Accessibility Survey

7th Street - Birchdale Avenue to Cul-De-Sac

Disability Access Consultants

7th Street - Birchdale Avenue to Lakewood Boulevard

[Change In Level East Of Paramount Boulevard @ 33.948043724091, - 118.132735490799](#)

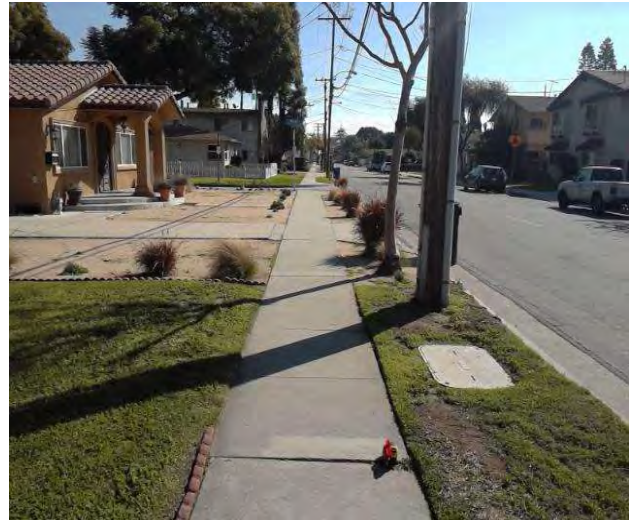
There is a change in elevation greater than recommended value.

On-Site Finding 0.50 inches

Ensure that the change in elevation is within the recommended value.

[Change In Level East Of Paramount Boulevard @ 33.948133836998, -118.132884353399](#)

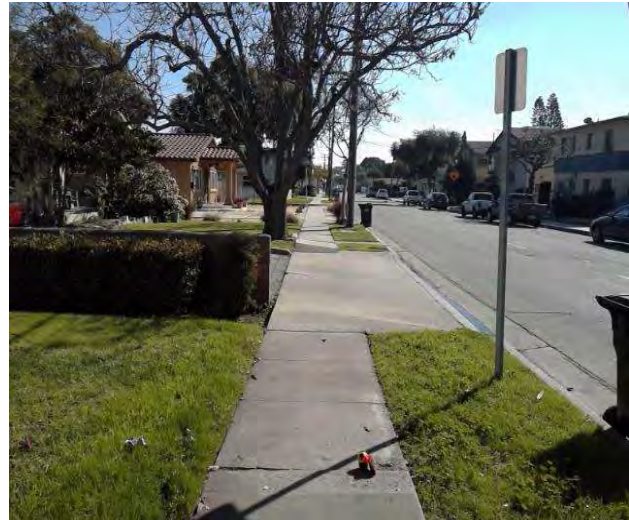
There is a change in elevation greater than recommended value.

On-Site Finding 1.00 inches

Ensure that the change in elevation is within the recommended value.

[Change In Level East Of Paramount Boulevard @ 33.948154974580, - 118.132963478565](#)

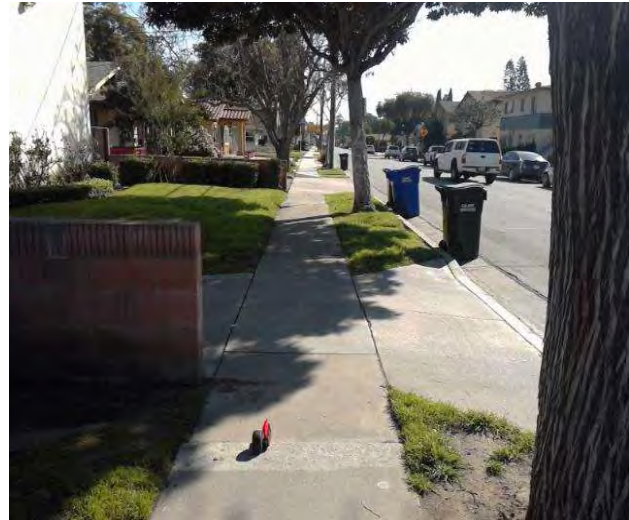
There is a change in elevation greater than recommended value.

On-Site Finding 0.50 inches

Ensure that the change in elevation is within the recommended value.

[Change In Level East Of Paramount Boulevard @ 33.948447562672, - 118.133516013622](#)

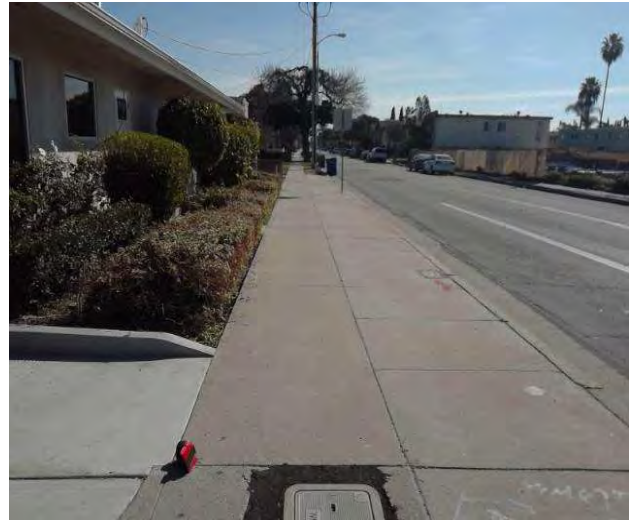
There is a change in elevation greater than recommended value.

On-Site Finding 0.50 inches

Ensure that the change in elevation is within the recommended value.

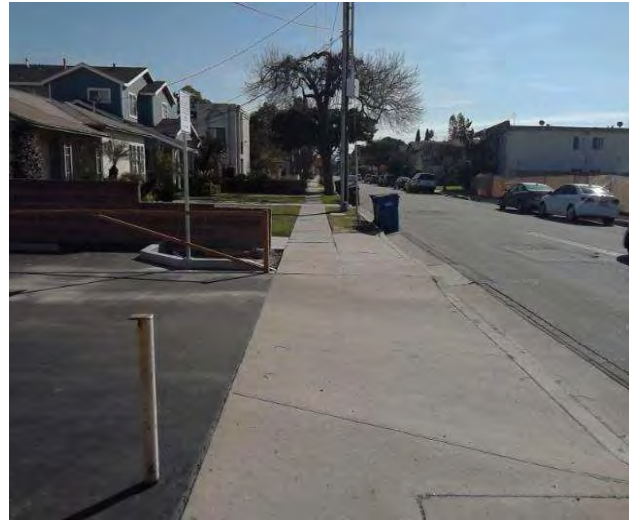
Cross slope at vehicular traffic is not compliant.

On-Site Finding 4.90 percent

Repave the surface to provide a compliant cross slope.

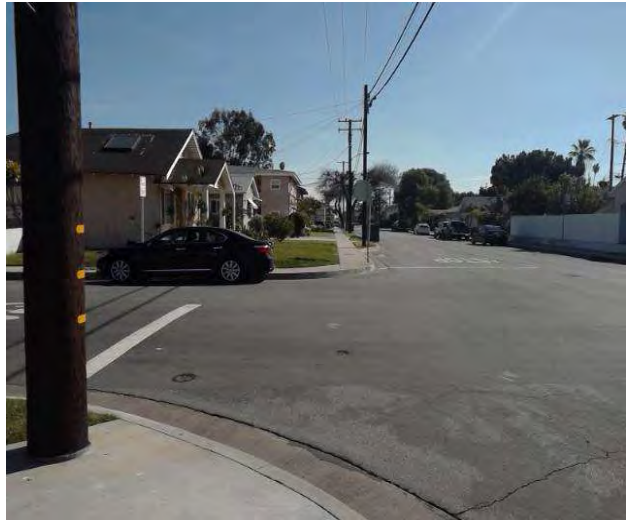
There is a curb on the designated path of travel.

On-Site Finding Not Compliant

Provide a compliant curb ramp.
